## Proposal for amendments to Draft new Regulation on uniform provisions concerning the approval of enhanced Child Restraint Systems used onboard of motor vehicles

### I. Proposal

Figure 2 : Side and Front View of the measuring device

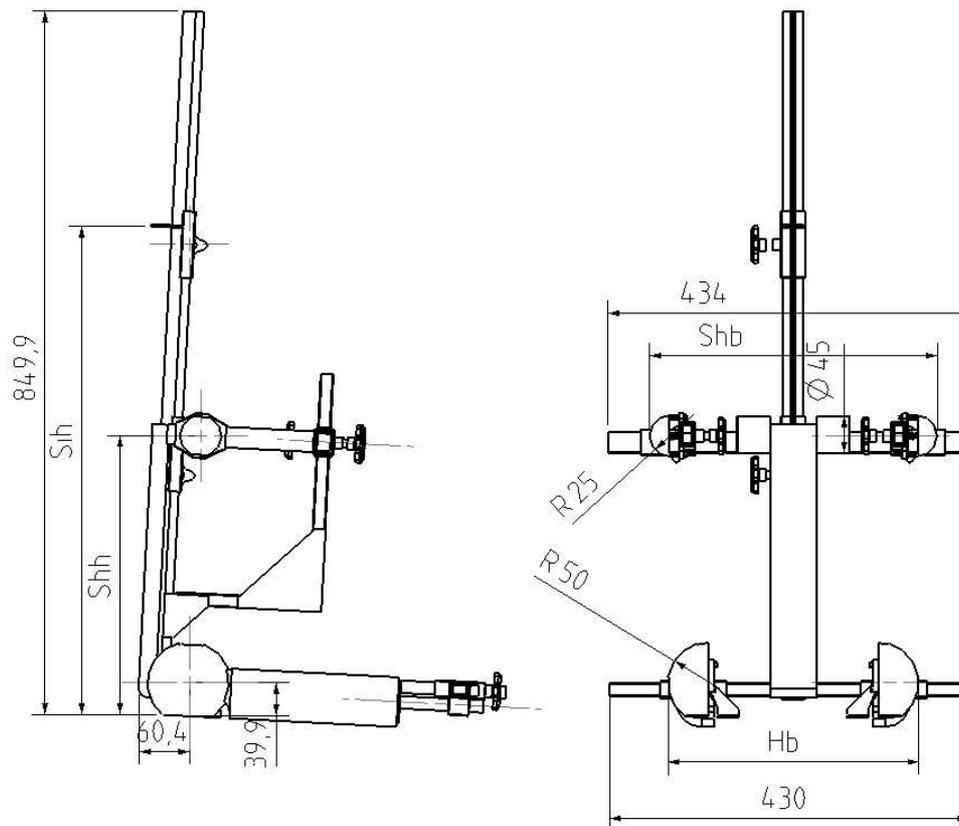
Annex 18 figure 2 :

Replace current drawing by the followings:

The current figure doesn't represent contact areas of the child with the CRS (hip, shoulder). The range of measurements of the current device is not in line with table 1 Annex 18. The adjusting system to measure dimensions must be not interfere with the CRS inner surface.

Hb : Hip Breadth variable from 140 to 380 mm

Scb : Shoulder Breadth variable from 120 to 400 mm

Sih : Sitting height variable from 400 to 800 mm

Shh : Shoulder height variable from 270 to 540 mm
